ALTERNATIVE 6

ALTERNATIVE 7

Updated 12/16/03

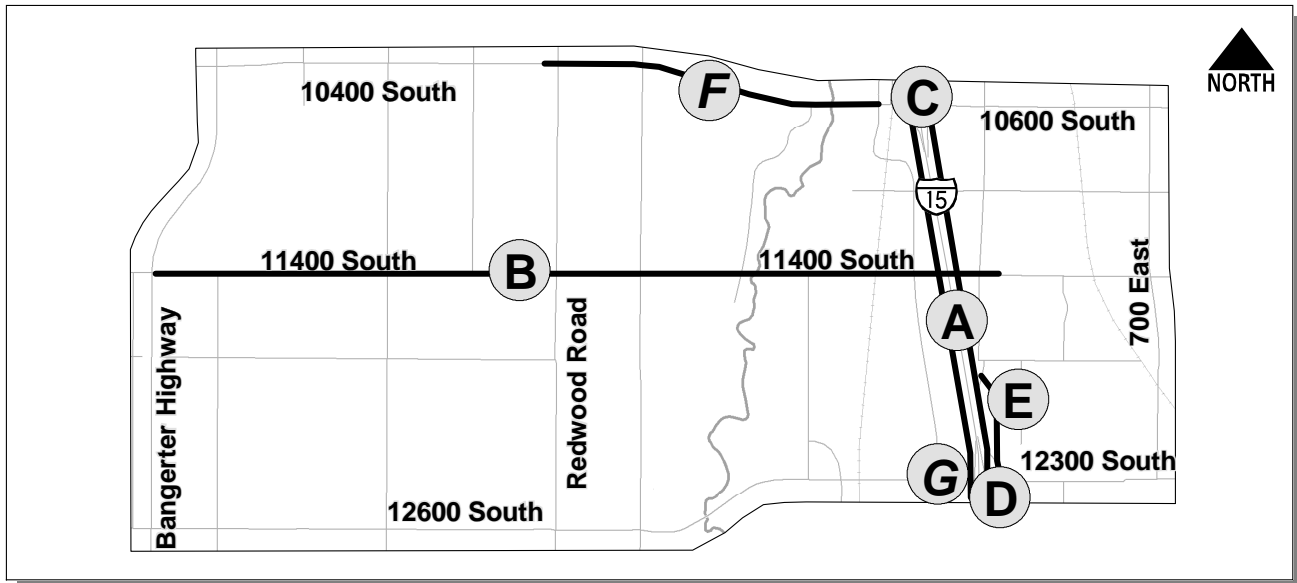
- A: Add one-way frontage roads along I-15 between 10600 South and 12300 South
 - B: Widen 11400 South to a four lane* section and add river crossing
 - C: Interchange modifications required at 10600 South and I-15
 - D: Interchange modifications required at 12300 South and I-15
 - E: Realign State Street between 11800 South and 12300 South (two options)
 - F: Widen 10600 South to six lanes* from Jordan Gateway to just west of Redwood Road
 - G: Widen 12300 South to six lanes* from Lone Peak Parkway to State Street
- * Assumes additional center lane or median

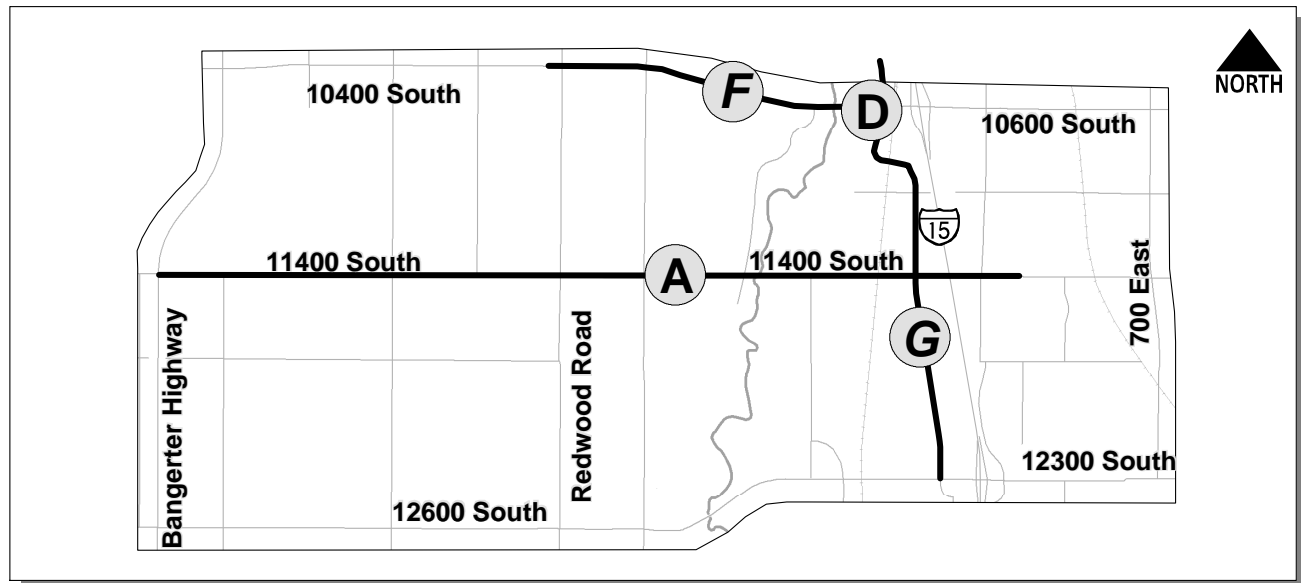
- A: Widen 11400 South to a four lane* section and add river crossing
 - ~~B: Possible modifications to I-15 interchange at 10600 South~~
 - ~~C: Possible modifications to I-15 interchange at 12300 South~~
 - D: Realign Jordan Gateway at 10600 South
 - ~~E: Look at possible interchange at 11400 South and Bangerter Highway (CTBD by traffic analysis)~~
 - F: Widen 10600 South to 6 lanes* from Jordan Gateway to just west of Redwood Road
 - G: Widen Jordan Gateway to 6 lanes* from 10600 South to 12300 South
 - H: Modifications to I-15 interchange at 10600 South - triple left SB to EB
- * Assumes additional center lane or median
